V2500 Propulsion System — Nacelle

SERVICE BULLETIN

NACELLE - EXHAUST - ATTACH HARDWARE, BLOCKER DOOR-TO-LINK ASSEMBLY
REPLACEMENT OF

V2500-NAC-78-0134

Blocker Door-To-Link Assembly Attach Hardware Replacement
Figure 1

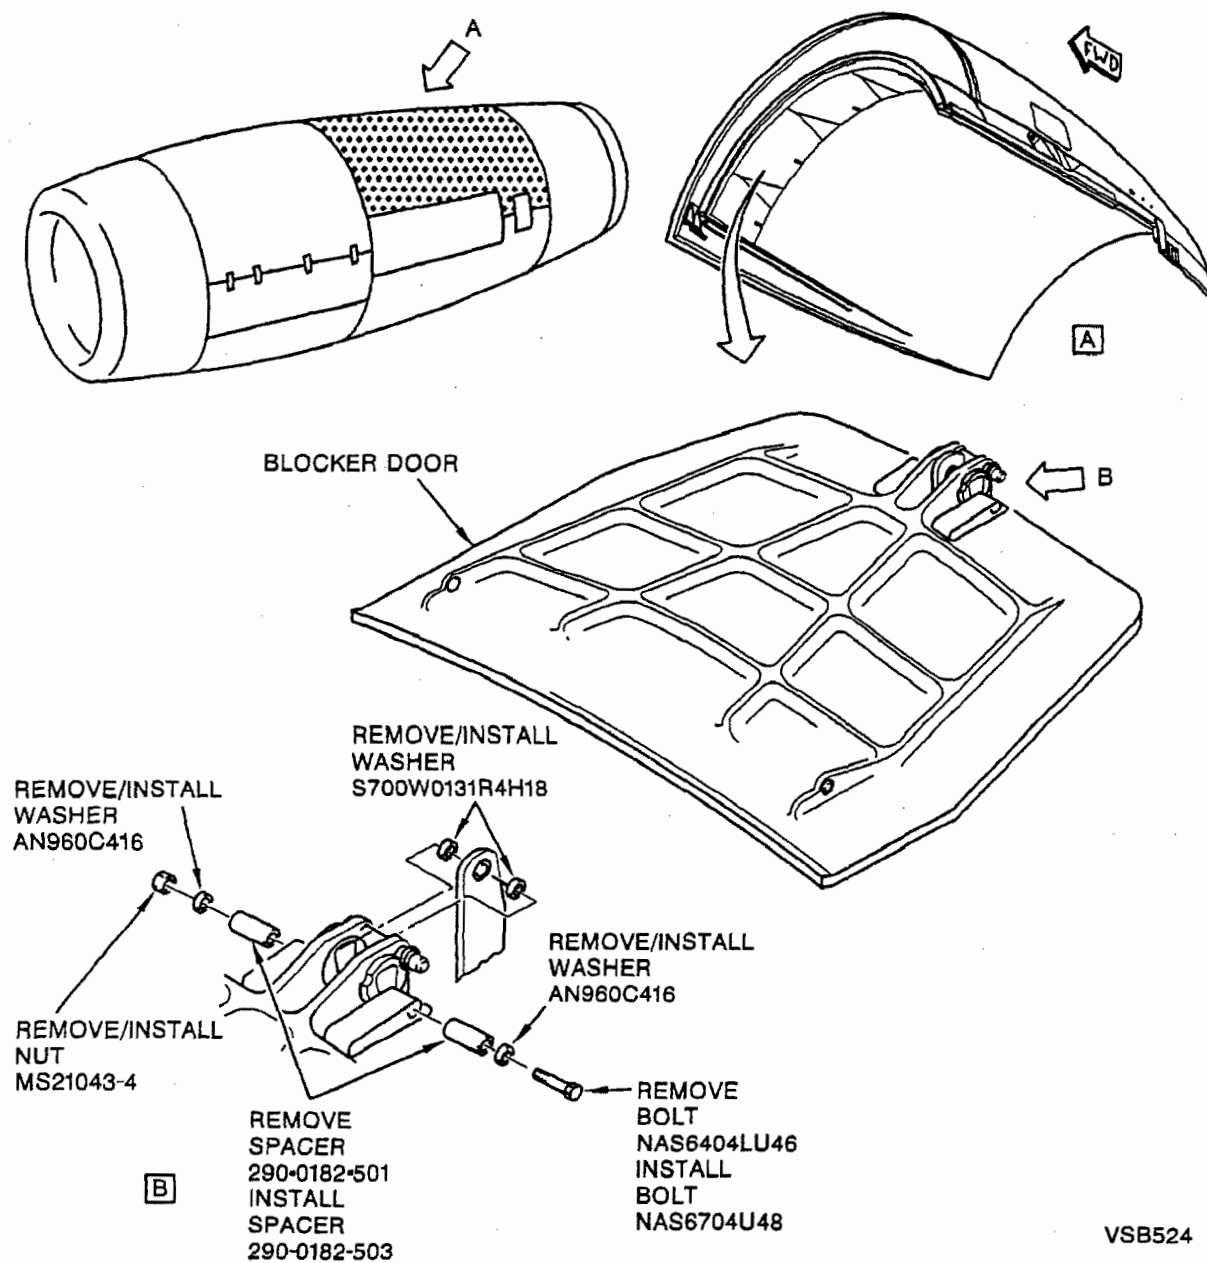
The thrust reverser blocker door-to-link assembly attach bolt and spacers are removed and new bolts and spacers are installed.

- (1) At 10 locations on each thrust reverser, remove the MS21043-4 nut, two AN960C416 washers, two S700W0131R4H18 washers, NAS6404LU46 bolt, and two 290-0182-501 spacers that attach the blocker door to the link assembly.
- (2) At 10 locations on each thrust reverser, install the two 290-0182-503 spacers, NAS6704U48 bolt, two AN960C416 washers, two S700W0131R4H18 washers, and MS21043-4 nut that attach the blocker door to the link assembly. Torque the nuts to 50 to 70 inch-pounds (5.7 to 7.9 Nm).
